## REMARKS/ARGUMENTS

### Specification and Drawings:

FIG. 2

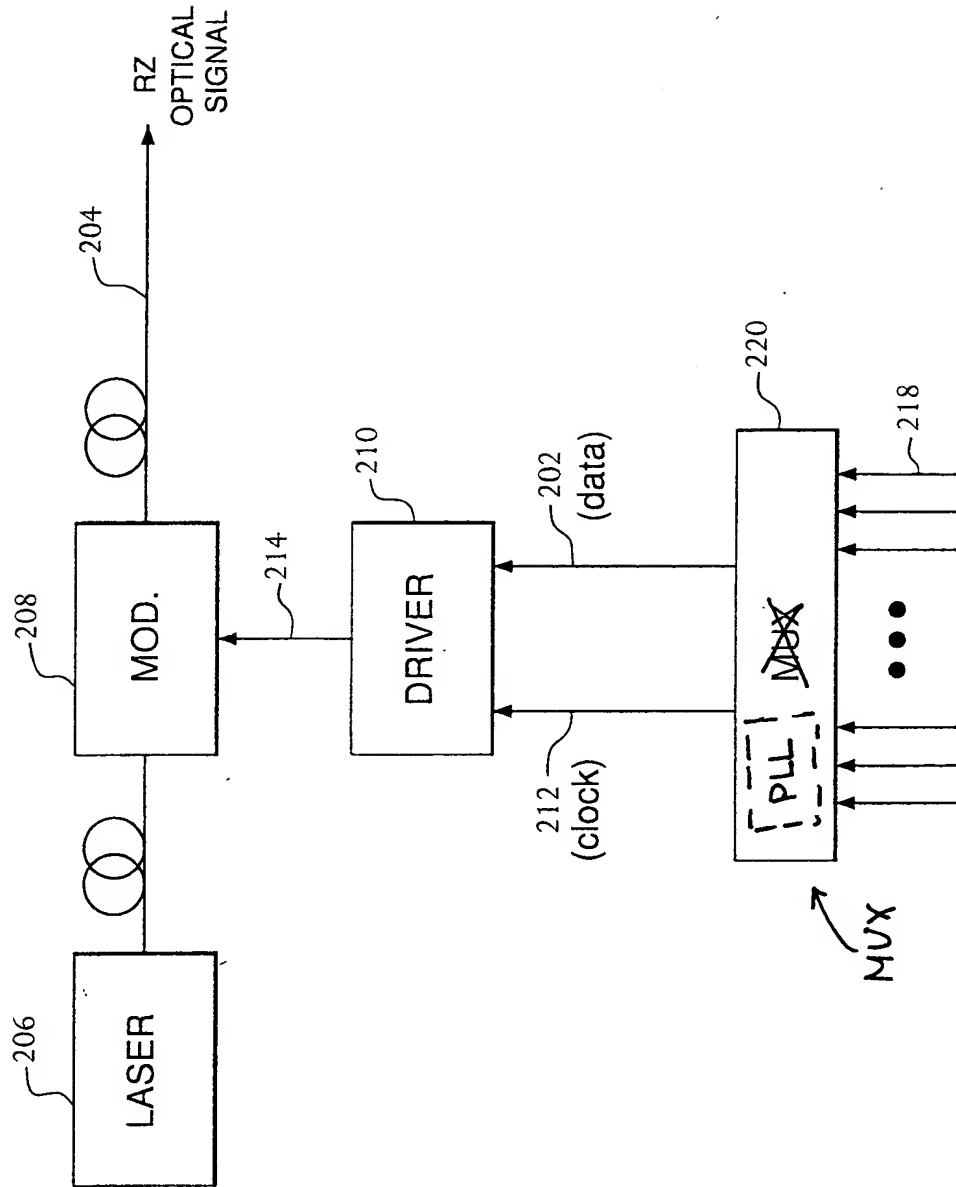
In paragraph 1 of the office action, the Examiner objected to the drawings for not showing every feature specified in the claims. More specifically, the Examiner stated that:

[T]he limitation “the amplifier comprises two or more amplification stages” in claim 8 and “the multiplexer includes a phase-locked loop circuit configured to lock the phase of the clock signal to the trunk NRZ signal” in claim 12 must be shown or the feature(s) canceled from the claim(s). No new matter should be added.

In response, the Applicant submits herewith a Transmittal of Corrected Drawings amending original Figs. 2 and 3 and adding new Fig. 3B. Support for the amendment of Fig. 2 can be found, e.g., on page 3, lines 18-20, and original claim 12. Support for new Fig. 3B can be found, e.g., on page 4, line 32, through page 5, line 5. The specification has been amended to reflect the addition of Fig. 3B and designation of original Fig. 3 as Fig. 3A.
